# Migrating from the LAN9215 to the LAN9210

## 1 Objective

The purpose of this application note is to assist SMSC customers with existing LAN9215 designs when upgrading to the new LAN9210 device. This upgrade is straightforward, but does require a PCB change to support a different package. This application note addresses all the differences between the LAN9215 and the LAN9210 devices, making this transition as easy as possible.

Figure 2.1 PCB Land Pattern

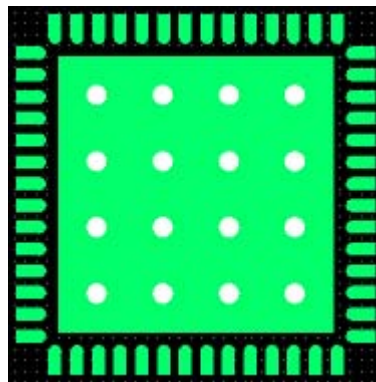
The LAN9210 is packaged in a 56-pin QFN with an exposed VSS pad. Therefore, the LAN9210 is not a drop in replacement for the LAN9215 and will require a new PCB. The recommended PCB land pattern can be found in Chapter 8 of the LAN9210 Datasheet. It is recommended to place a 4x4 grid of vias at 60mil spacing in the exposed pad area for connection to the board's ground plane, as shown in [Figure 2.1](#) below. Please consult with your Assembly House for their process capabilities and recommendations.

### Figure 2.2 Power Connections

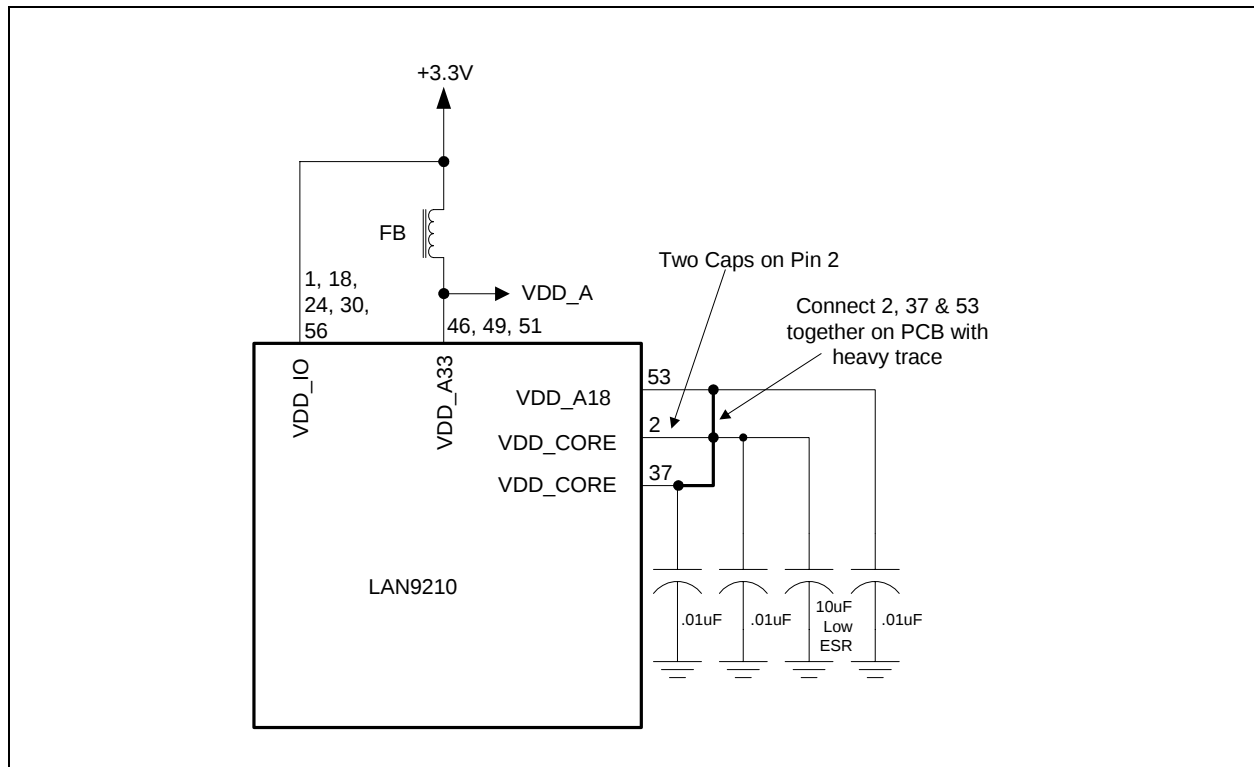
The LAN9215 has several different ground pins (GND\_IO, VSS\_A, GND\_CORE, VSS\_PLL and VSS\_REF). However, the LAN9210 uses a single ground connection (VSS) on the exposed pad. Also, the LAN9210 does not have VDD\_PLL, VDD\_REF and VREG power pins.

The LAN9210 has a VDD\_A18 (pin 53) that must be externally connected to VDD\_CORE (pins 2, 37) with traces at least 10 mil wide and connected to a 10uF low ESR ceramic capacitor. Each of these 3 pins must be individually decoupled with a 0.01uF capacitor as close as possible to the pin, as shown in [Figure 2.2, "Power Connections"](#).
